ADDENDUM NO. 2

December 9, 2022

BAILLY ELEMENTARY SCHOOL ADDITIONS AND RENOVATIONS Chesterton, IN 46304

Addendum Two (AD.02) to the drawings and specifications prepared by Gibraltar Design for **Bailly Elementary School Renovations** for Duneland School Corporation, Chesterton, Indiana.

UNIT "E" FIRST FLOOR
REFLECTED CEILING PLAN

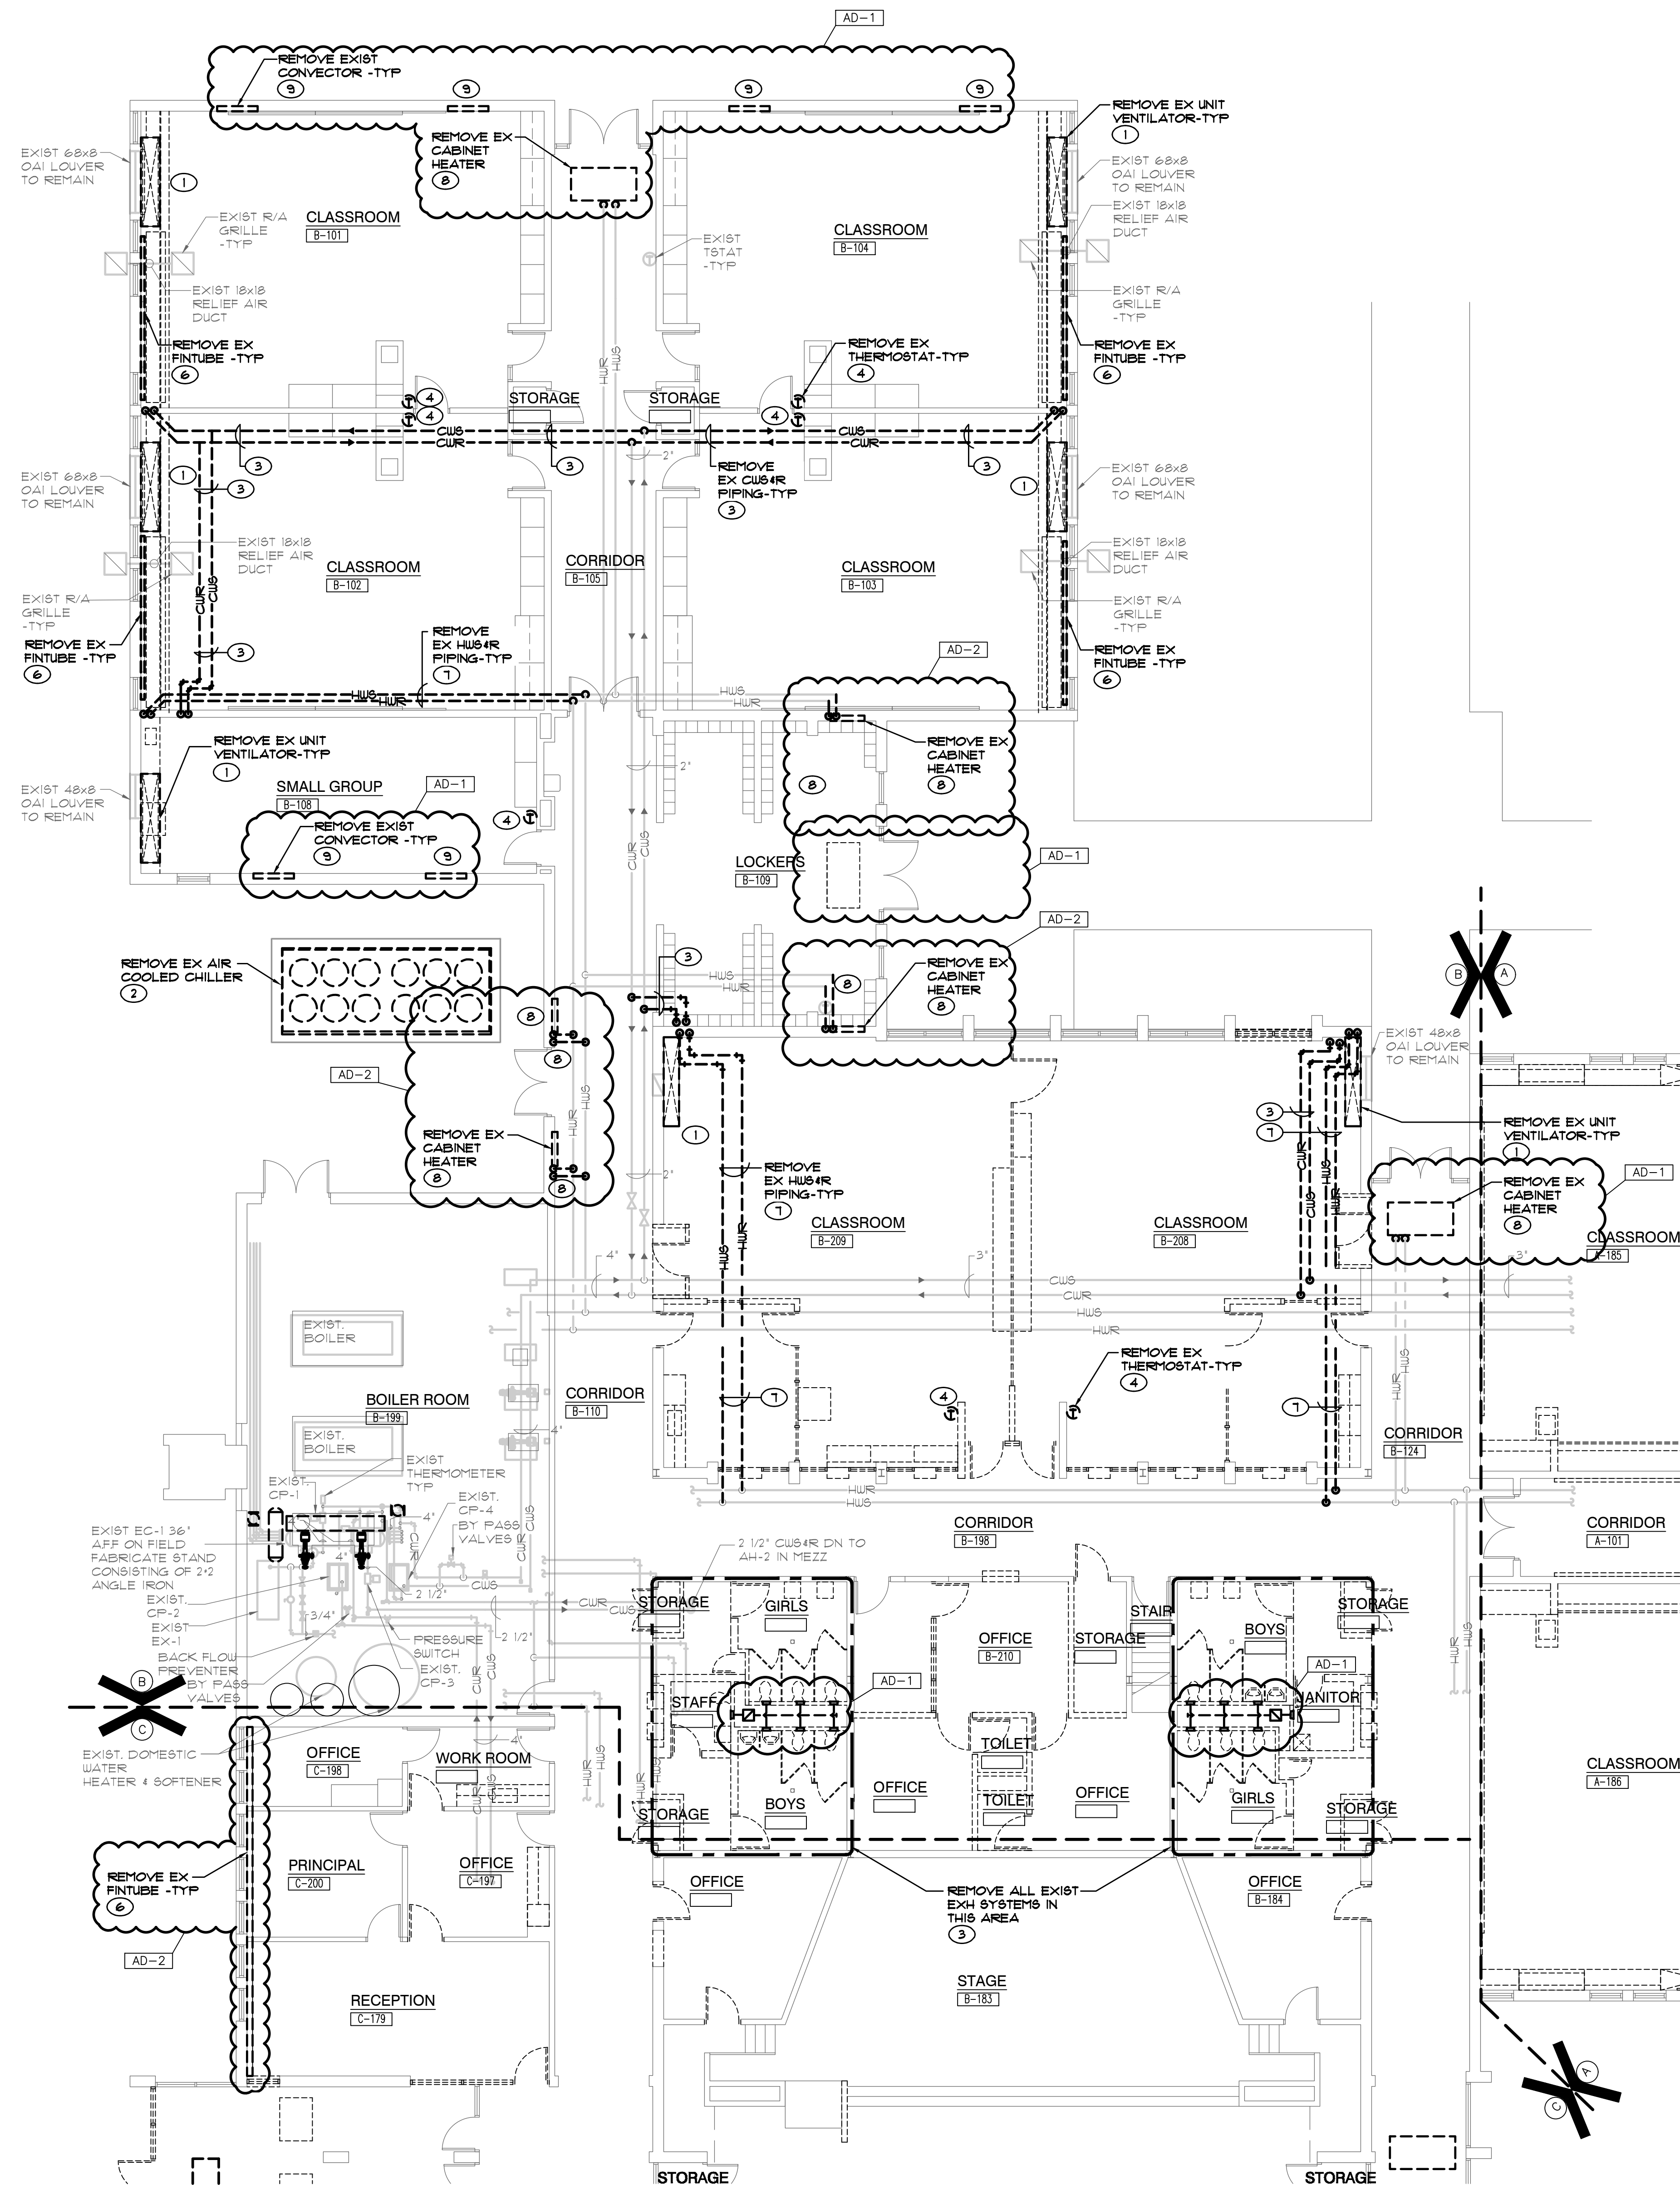
- A. Refer to revised full size drawing included in this addendum for the following revisions:
1. Update ceiling orientation in the following rooms: Music E-120, Media E-126, Classroom E-127.
 2. Update to indicate new acoustical ceiling grid, pads and suspension system in the following rooms: Classroom E-127, Media E-126, Storage E-125, Storage E-124, Office E-123, Media Center E-126, Storage Area E-129, Music E-120.
 3. Update Storage E-121 as indicated.

© GIBRALTAR DESIGN SHEET
C MP103

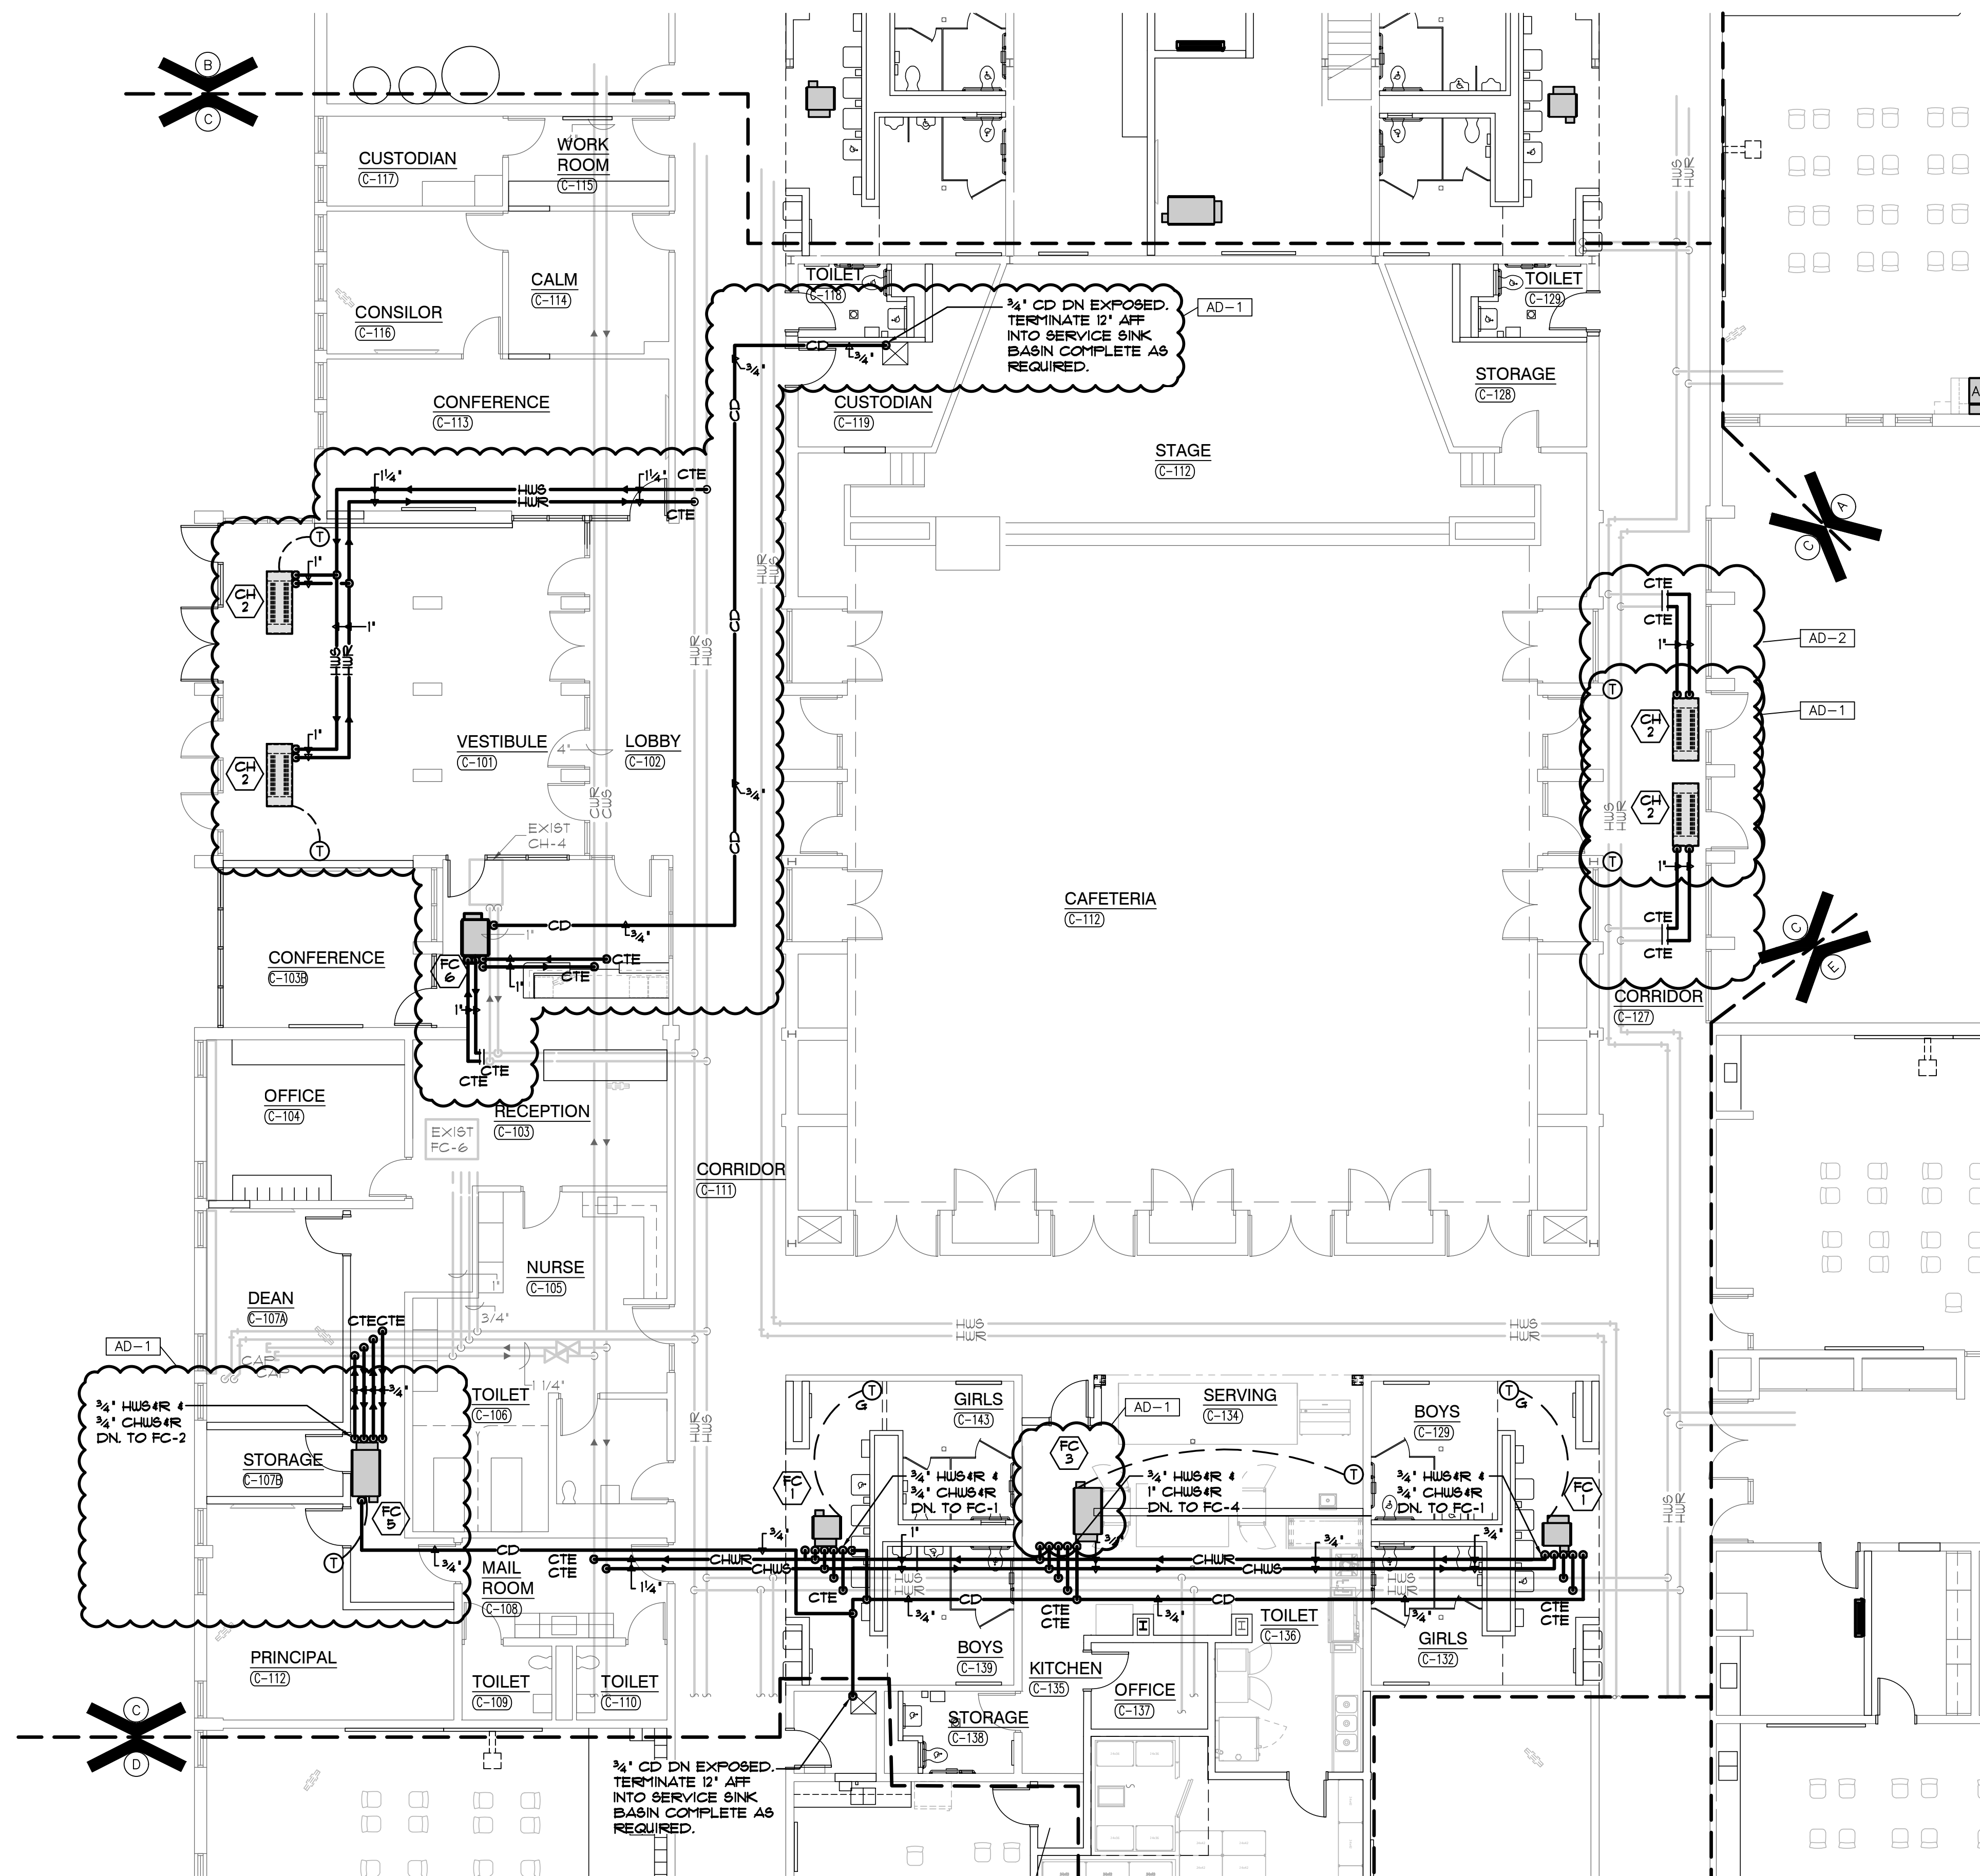
- A. Refer to revised full size drawing included in this addendum for the following revisions:
 - 1. Added existing cabinet heaters to be removed.
 - 2. Revised demolition of existing cabinet heaters.
 - 3. Added existing fin tube to be removed.
 - 4. Added demo fin tube sheet note.

© GIBRALTAR DESIGN SHEET
D MP104

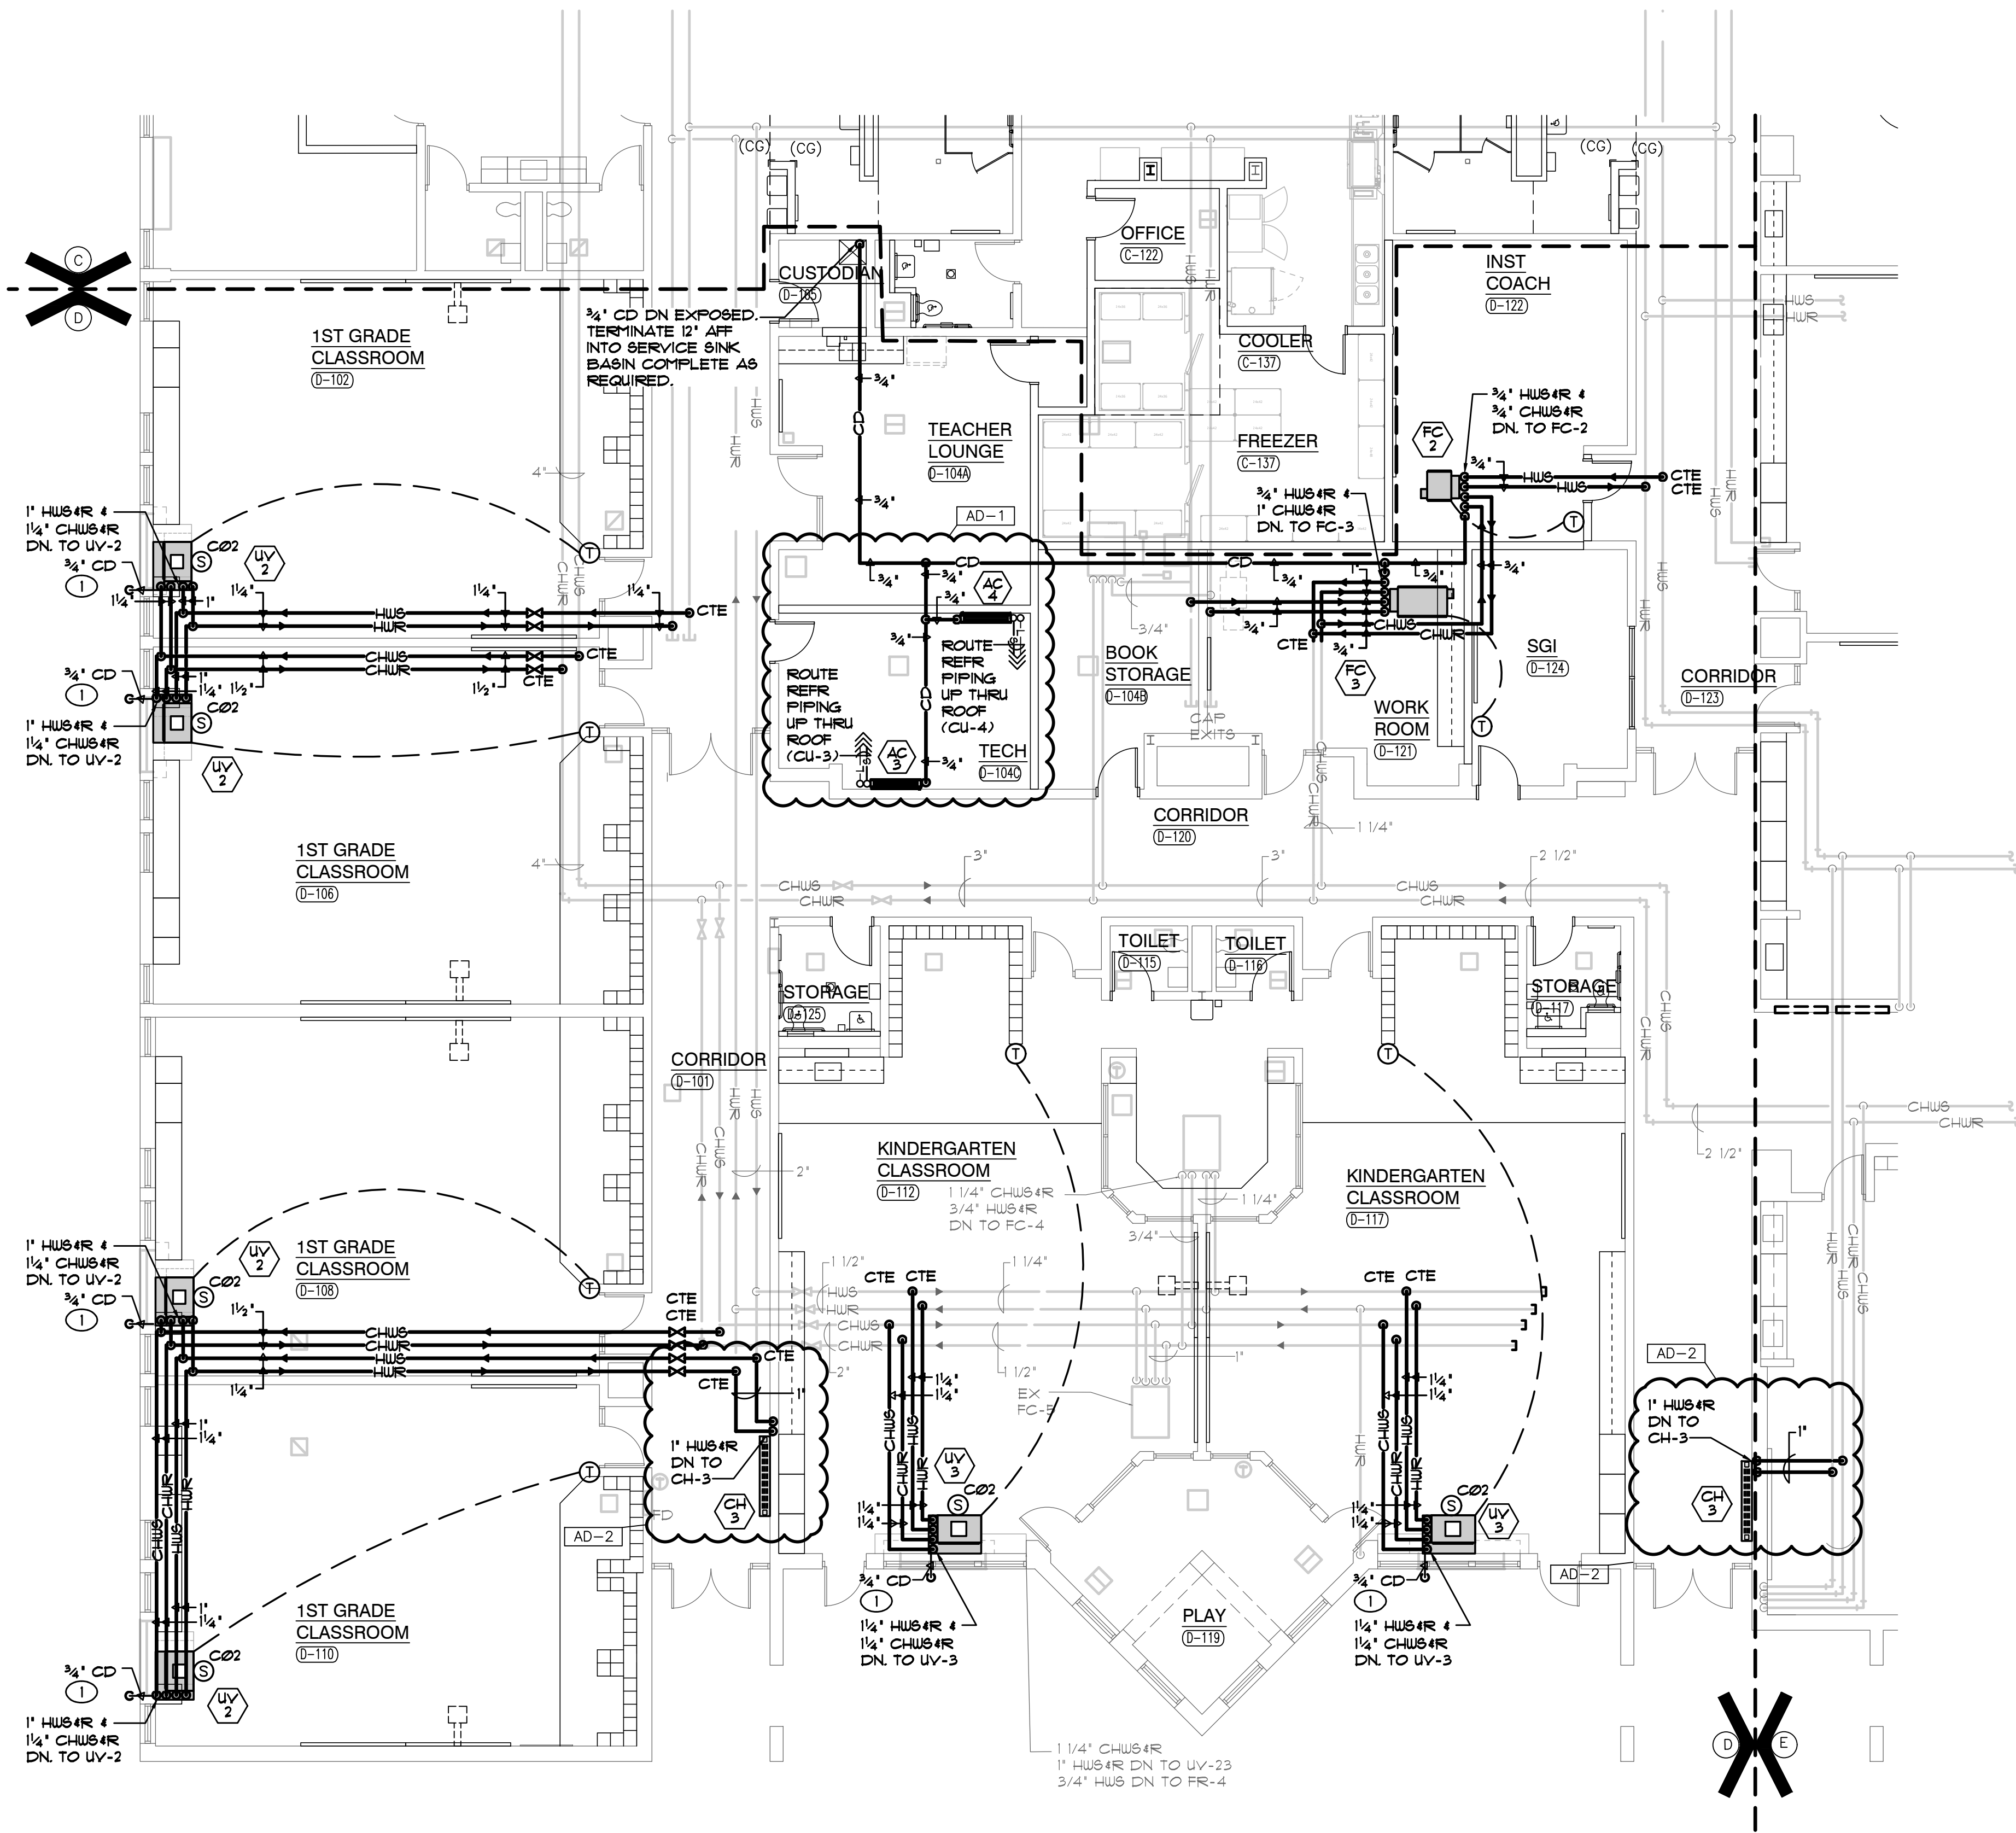
- A. Refer to revised full size drawing included in this addendum for revised new cabinet heaters and associated piping.
